URGENT FIELD SAFETY NOTICE
bellavista™ Ventilators
Ceasing of Ventilation with Technical Failure Alarm 305
for Field Safety Corrective Action FSCA-2021-001

17 December 2021

FSN Ref: FSCA-2021-001-FSN-1

Attention: Distributors and users of bellavista™ ventilators (1000, 1000 US, 1000e, 1000e US, 1000 neo and 1000 Set).

1. Open **Configuration Assist**.

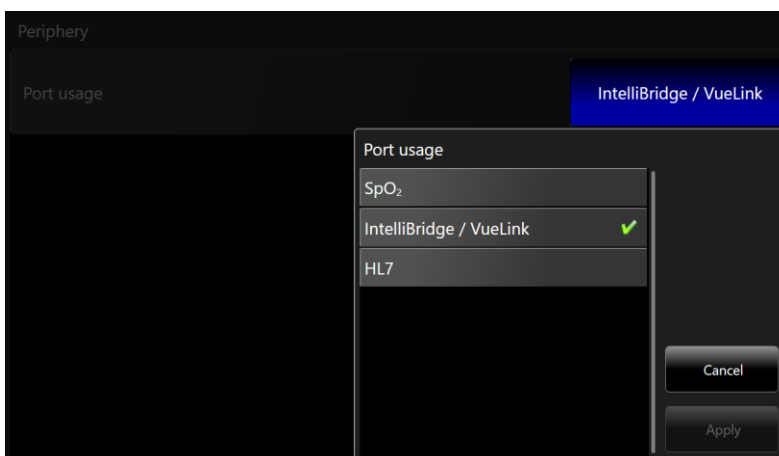
- If affected devices are transferred to another location or organization, make sure to forward the complete FSCA package to the respective users accordingly.
- All users of the affected products shall read and take into consideration all instructions and information provided in this *FSN*.
- Identify any affected devices by serial number using the Units Affected List in the separate, attached document, *Appendix to Urgent Field Safety Notice FSCA-2021-001-FSN-1: Units Affected List for FSCA-2021-001*.
- It is mandatory to disable the HL7 protocol where enabled.
- Perform the following steps on each affected bellavista™ ventilator until the software patch to fix the issue is available:
